Dated February 8, 2023

Addendum No. 2

Invitation for Bid (IFB) V-2213

Bathroom Renovation at Mitchel Field

LIGHTING - BATHROOMS PARTIAL REFLECTED CEILING PLAN NASSAU INTER-COUNTY EXPRESS 700 COMMERCIAL AVE

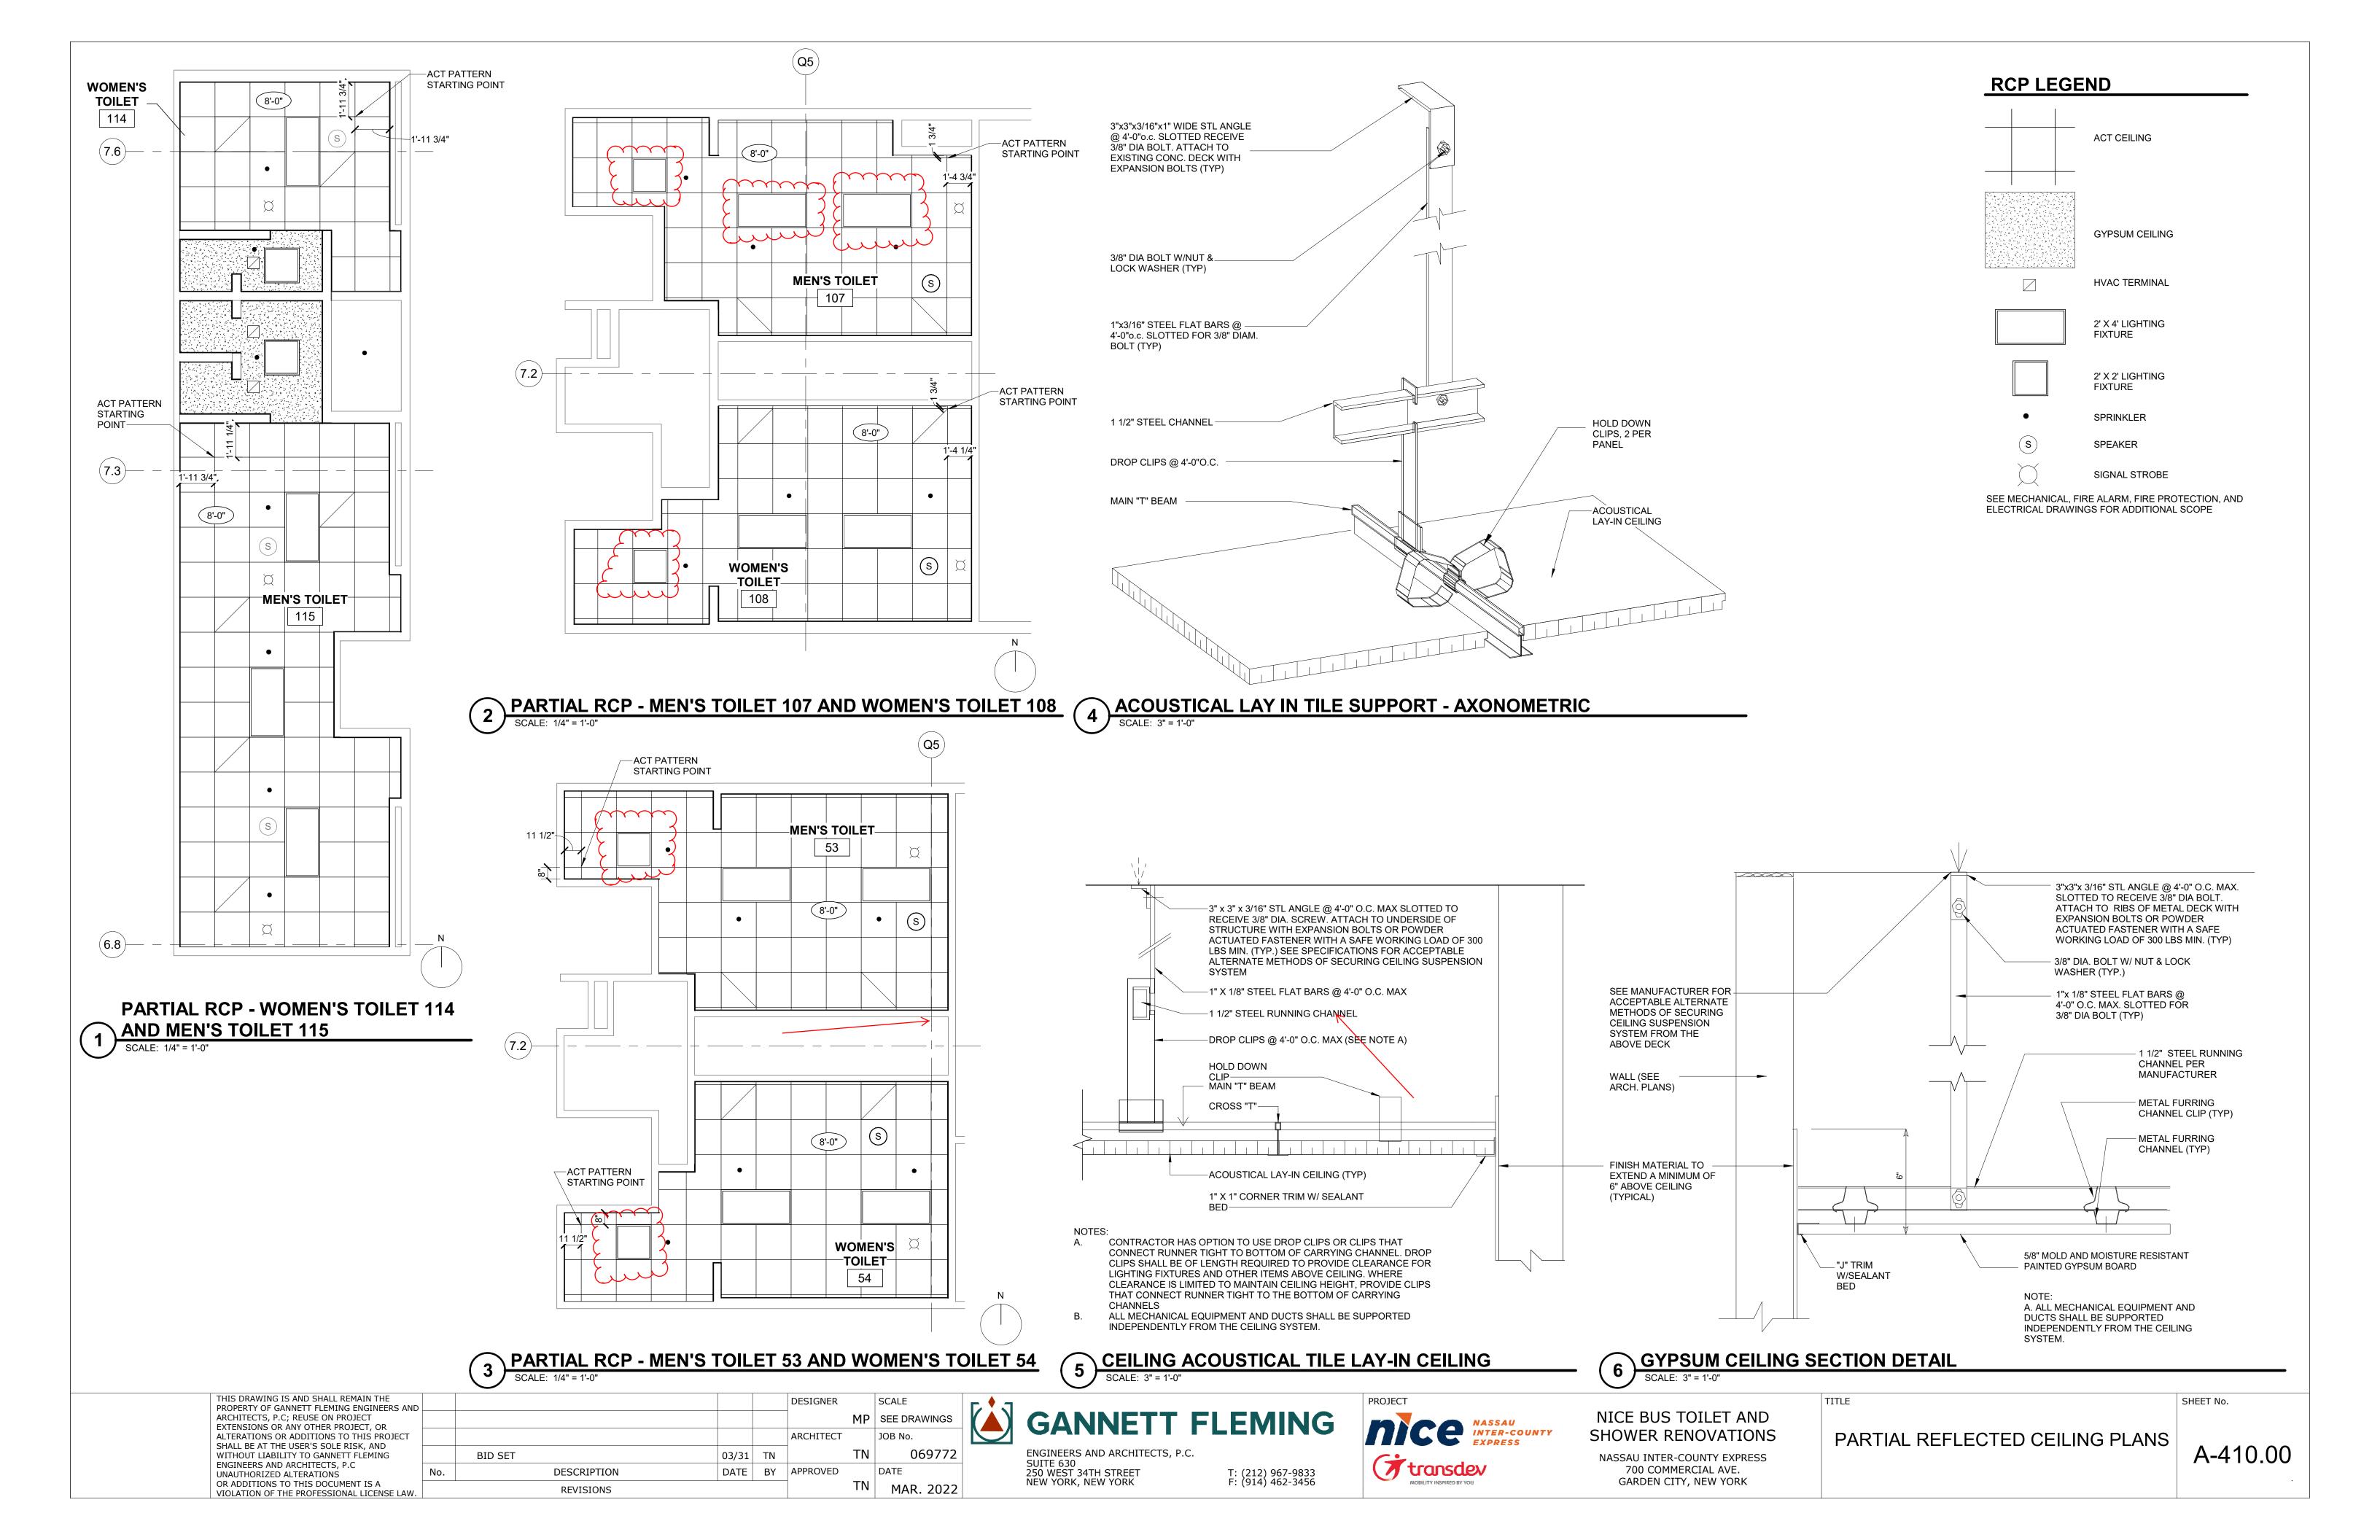
Response to	County, as applicable OR on the Nassau County Living Wage – whichever labor
	question 7	rate is higher.
8	Bidder Question:	Would you know whether or not you would be accepting MBE or WBE in place of DBEs?
	NICE Bus Response to question 8	No; please see answer to question 4 in this Addendum No. 2 for additional detail.
9	Bidder Question:	We asked this question previously and response in addendum no 1 question no 18 however we believe this response is incorrect. Please see attached drawing pages A410 and E103 where in toilets 107/108/53/54 a 2x2 type G light fixture is missing in the E103 versus A410. Please clarify?

NICE Bus Response to question 9	First part: A-410 and E-103 match. Please see attached sheet E-103 showing more clearly the location of the Mark G lamps. Please note only linework was updated and there are no changes to the scope.								
		Second part -ADA pipe covers are required. Provide sink plumbing covers and mounting carriers as per 10/A-602 REFER TO -Consider a single color from Sophstone standard color options. -Consider the Standard Equipment for BRADLEY Model 1C (NONE for additional								
10	Bidder Question:	selections) At this point, do you have an estimated lead time for when the Dyson hand dryers would be needed on site?								
	NICE Bus Response to question 10	Contractor to reach out to prime contractor to verify lead times.								
11	Bidder Question:	Please let us know what is the insurance requirement for a subcontractor? Is it the same as the Prime contractor?								
	NICE Bus Response to question 11	No, subs are not required to have the same as the prime. We would want you to issue your COI, but not the limits required by the prime.
